Accessibility Survey

City of Downey Mueller Street - Pangborn Avenue To Lesterford Avenue

Date of Inspection
5/4/2017

Disability Access Consultants

Sidewalk West Of Lesterford Avenue @ 33.934056154352, -118.107925057411

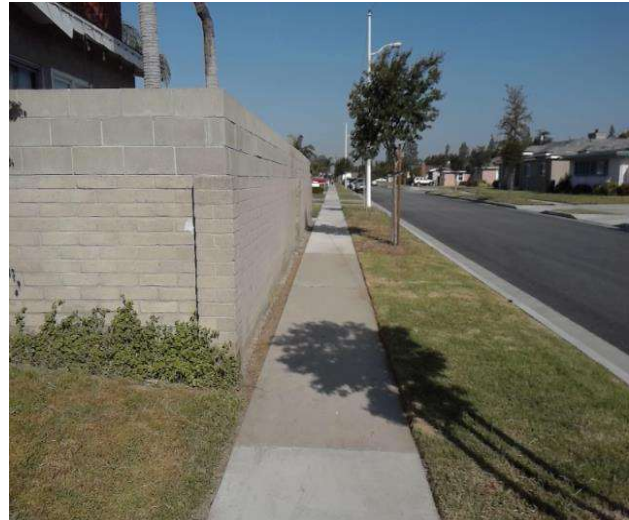
Sidewalk cross slope is not compliant.

On-Site Finding 4.30 percent for 15.00 feet

Repave the sidewalk surface with the recommended cross slope.

Recommendation Up to 2.08 percent

Sidewalk West Of Lesterford Avenue @ 33.934447819775, -118.108684122562

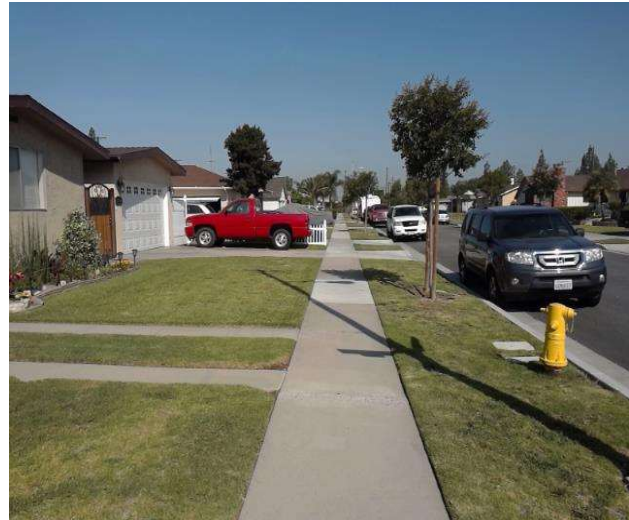
Sidewalk cross slope is not compliant.

On-Site Finding 5.00 percent for 15.00 feet

Repave the sidewalk surface with the recommended cross slope.

Recommendation Up to 2.08 percent

Tree West of Brookshire Avenue @ 33.943781608365, -118.125895857811

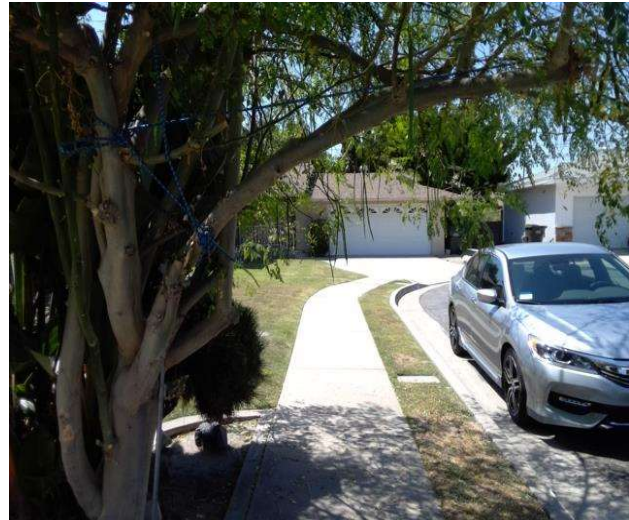
Overhead obstruction height is not compliant.

On-Site Finding 63.00 inches

Provide a compliant vertical clearance height.

Recommendation At least 80.00 inches

Change in Level West of Shellyfield Road @ 33.940757612975, -118.119808584452

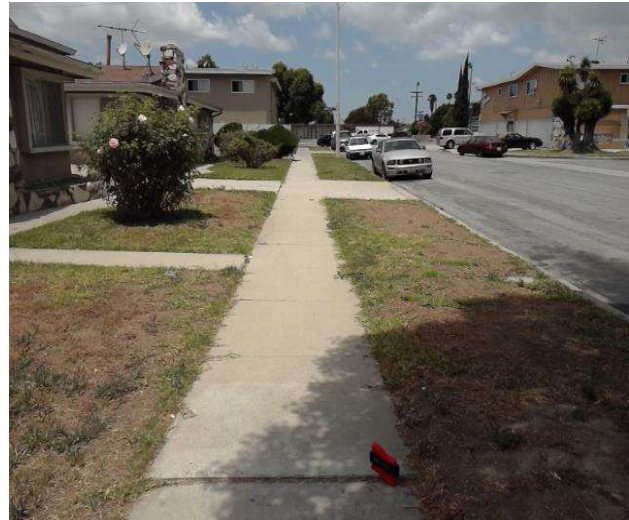
There is a change in elevation greater than recommended value.

On-Site Finding 0.75 inches

Ensure that the change in elevation is within the recommended value.

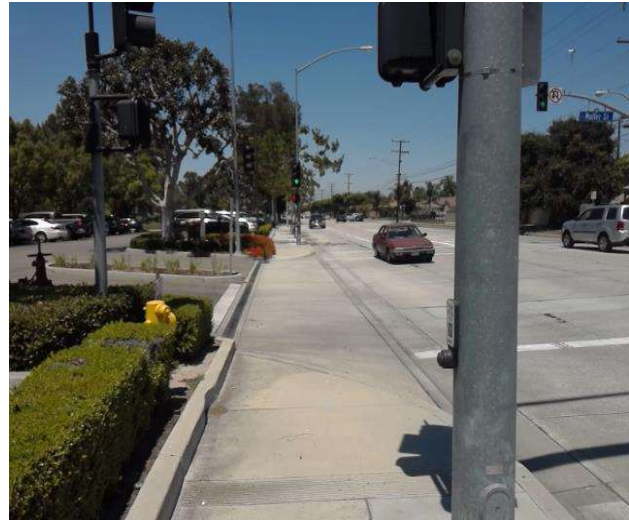
There is no crosswalk at the intersection.

On-Site Finding None Found

Provide a compliant crosswalk for the intersection.

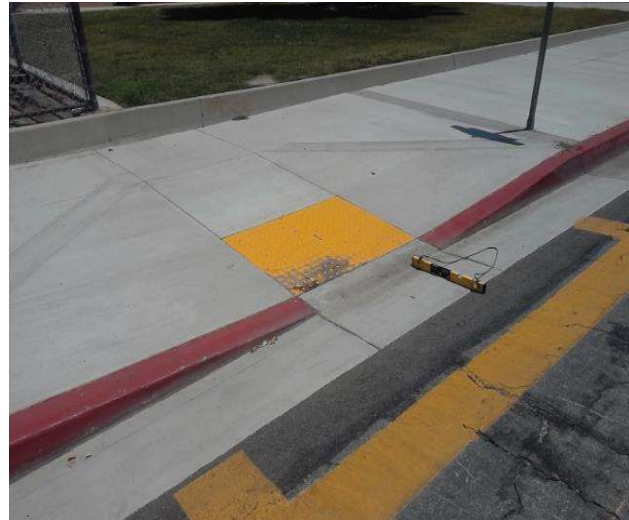
On-Site Finding 47.50 inches

Provide a level top landing with enough clear length.

Recommendation At least 48.00 inches
